ADDENDUM NO. 2

SIX CORNERS INTERSECTION IMPROVEMENT

PROJECT NAME
SW CANAL BLVD AT SIX CORNERS INTERSECTION IMPROVEMENTS

TYPICAL SECTIONS

DRAWING NO.
 3 OF 35
C2.0

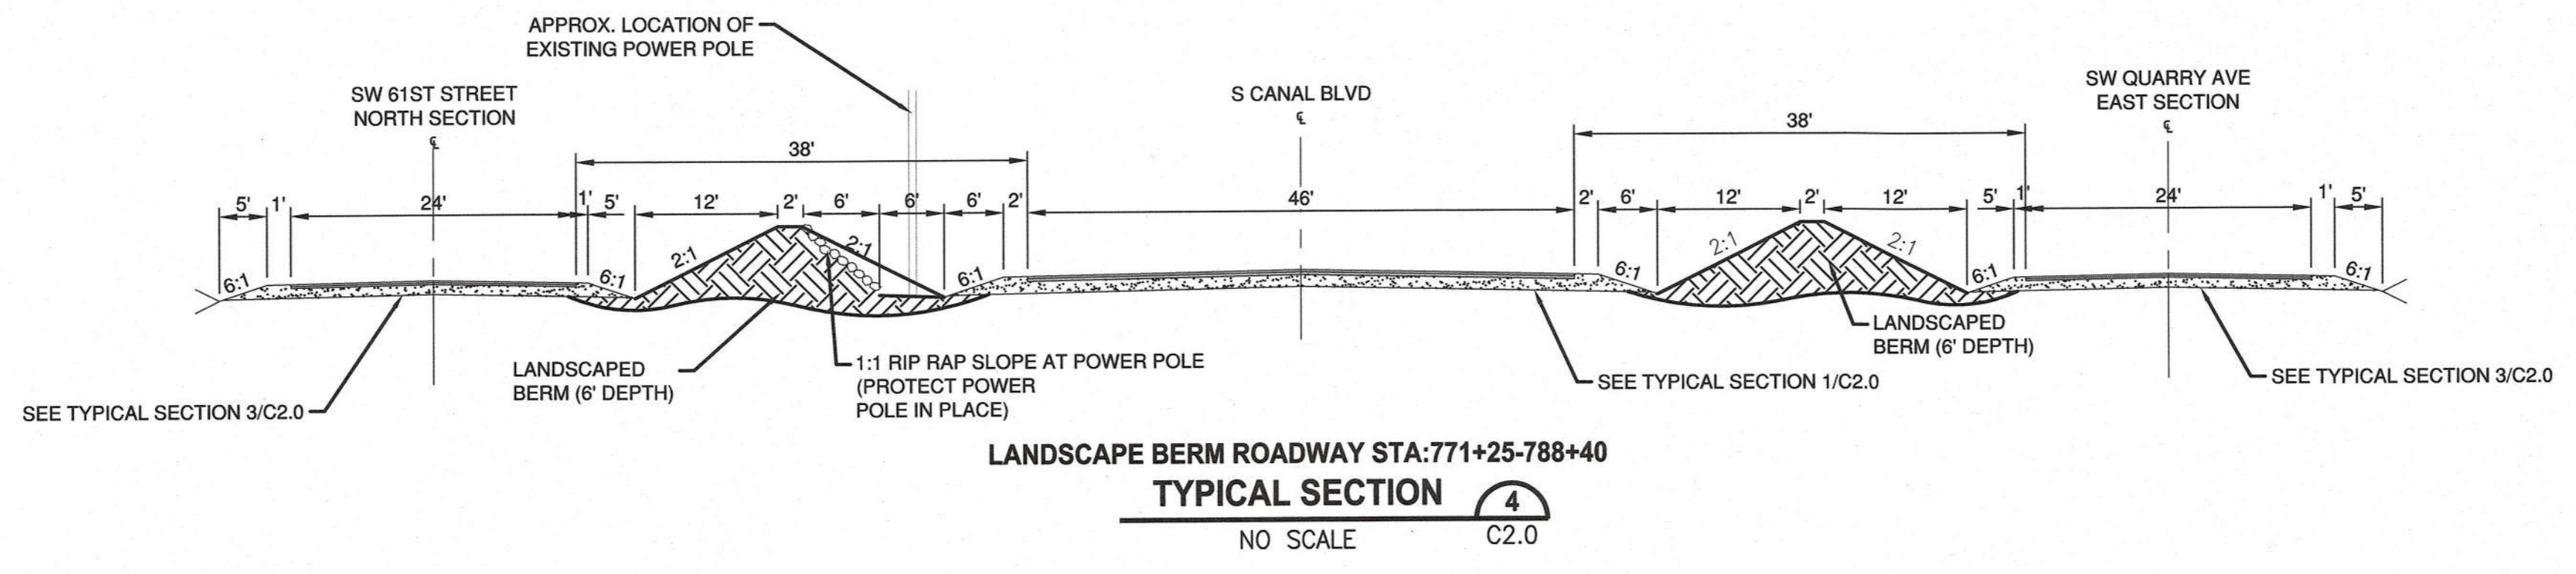
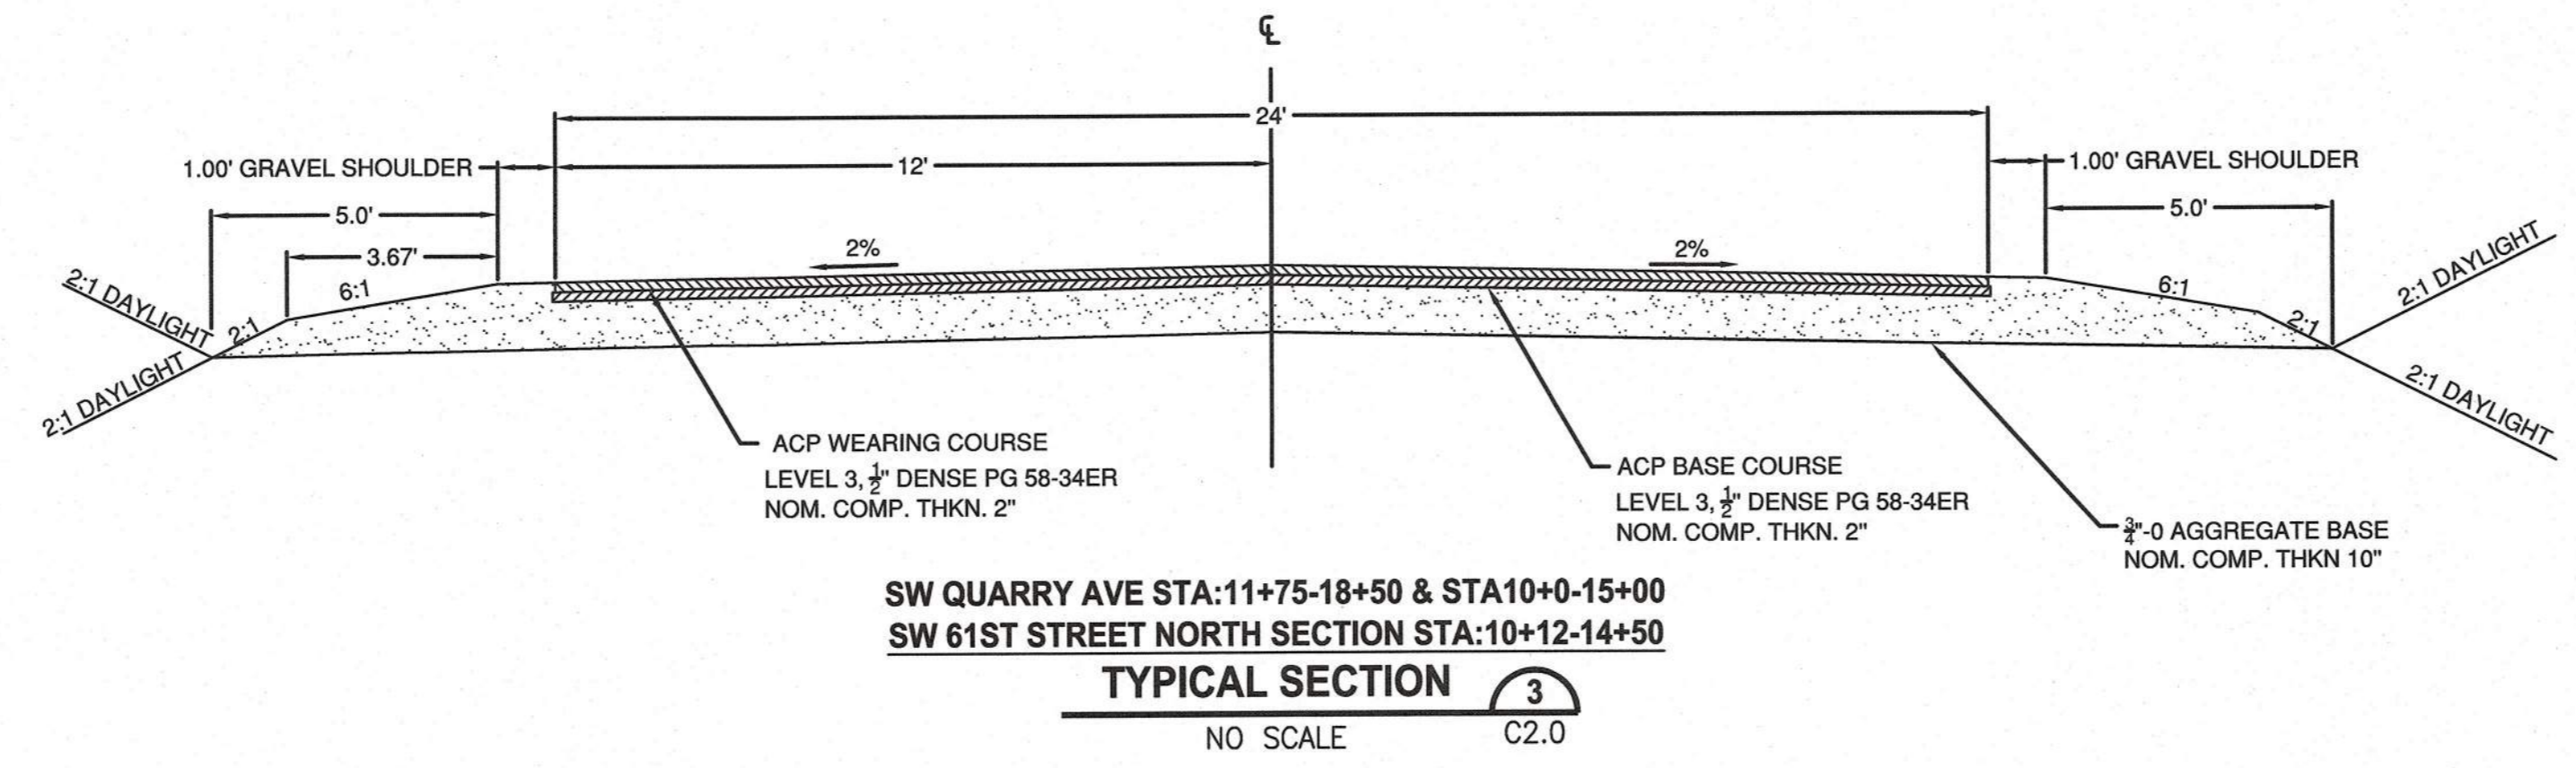
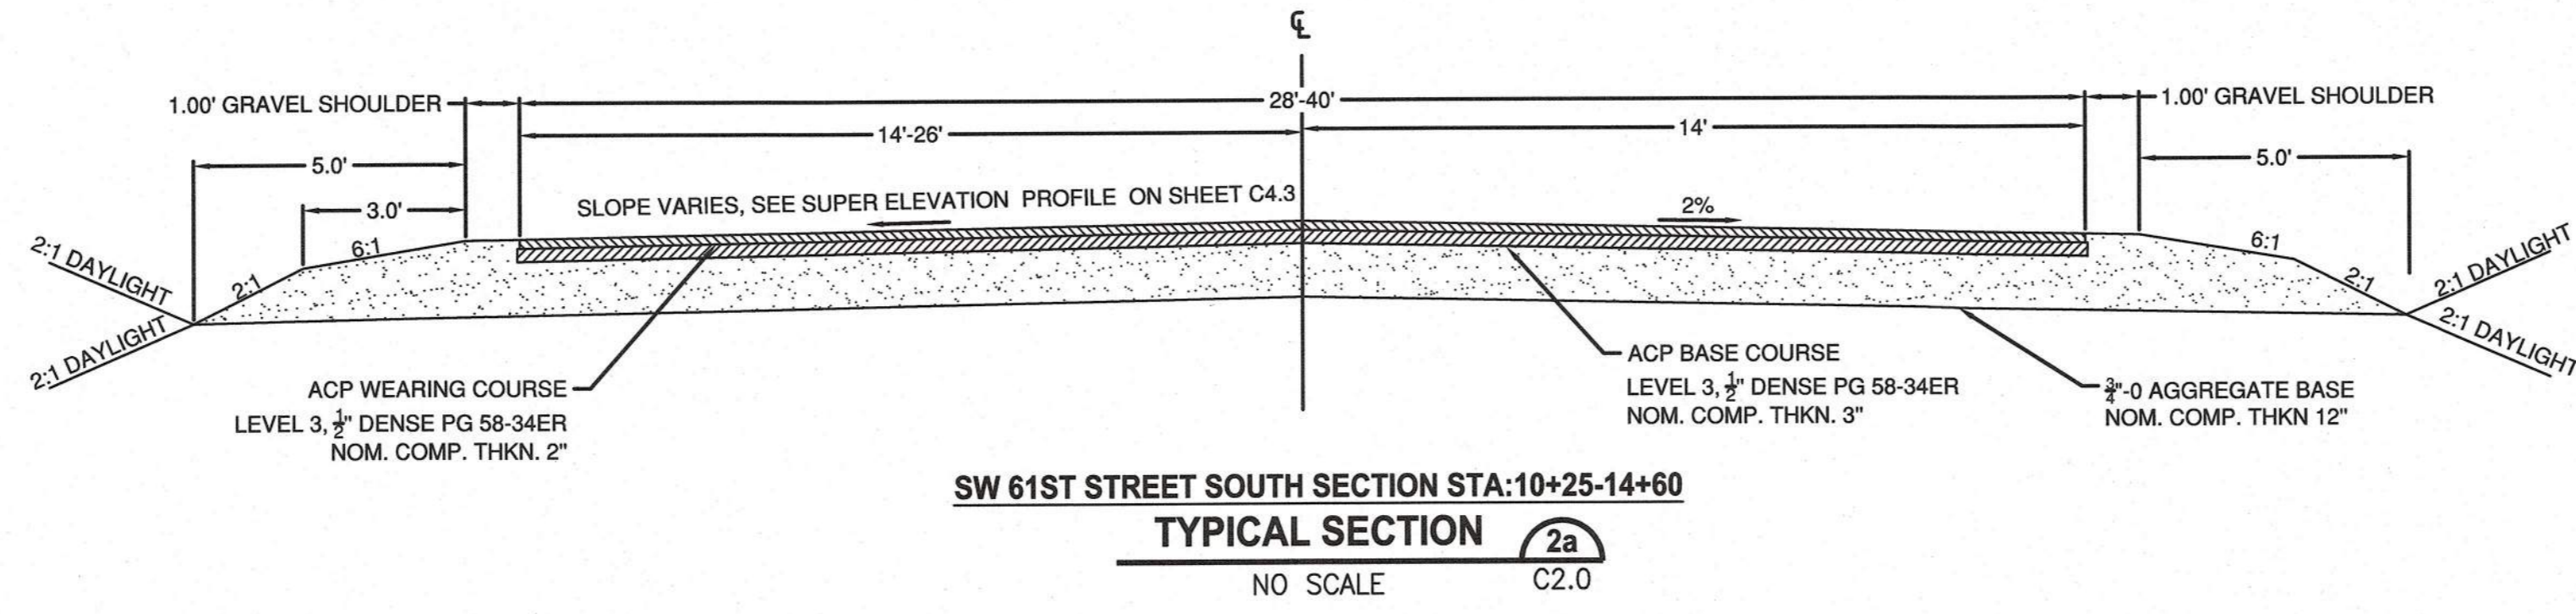
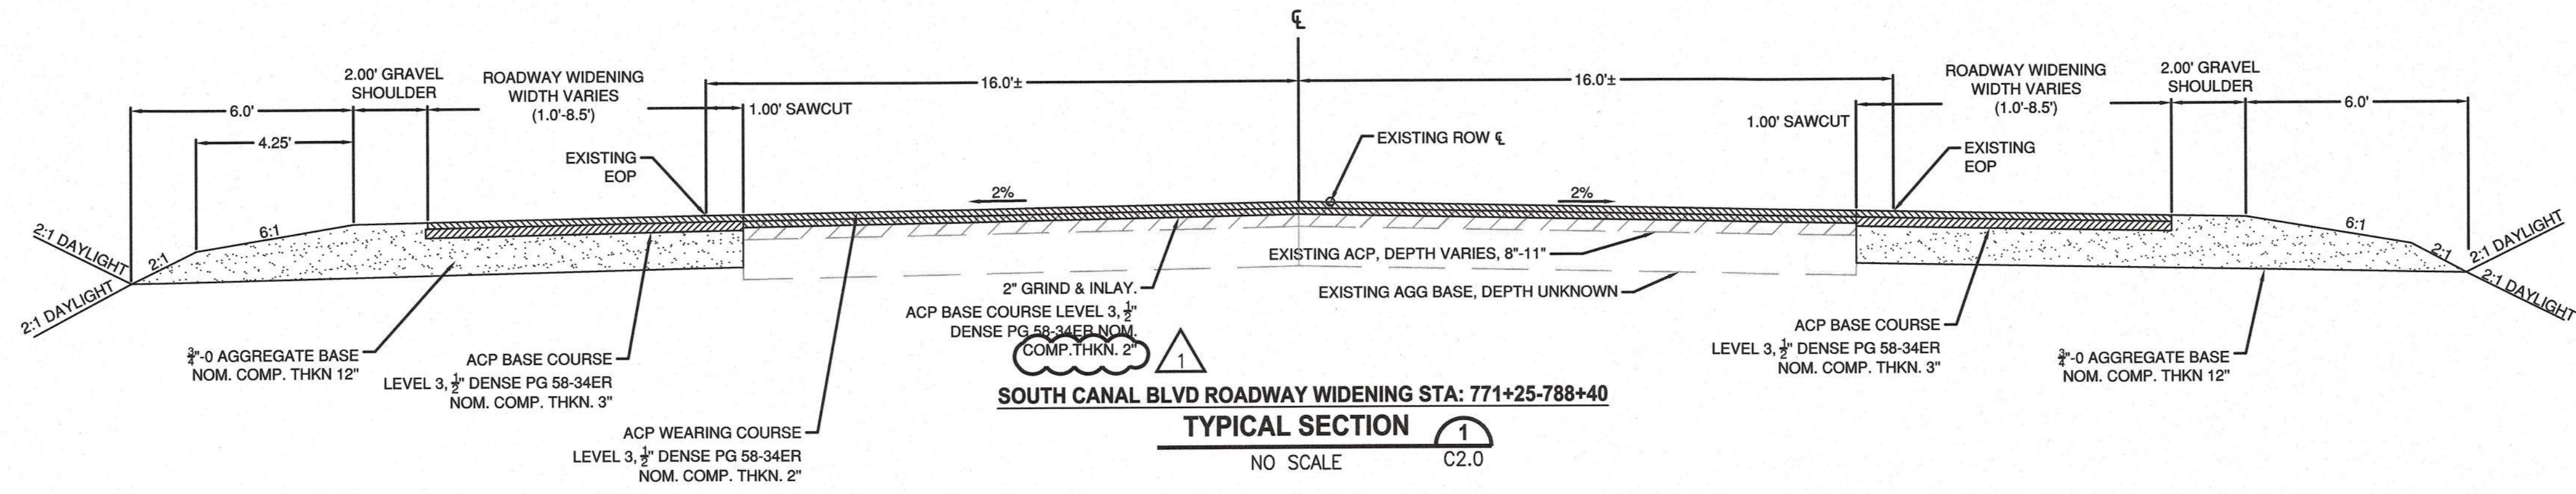
Replace Sheet C2.0 in the Bidding Plans with the attached Sheet C2.0.

This revised Sheet C2.0 clarifies that the inlayed base course section over the existing cold-planned ACP on Typical Section 1 will have a compacted thickness of 2 inches.
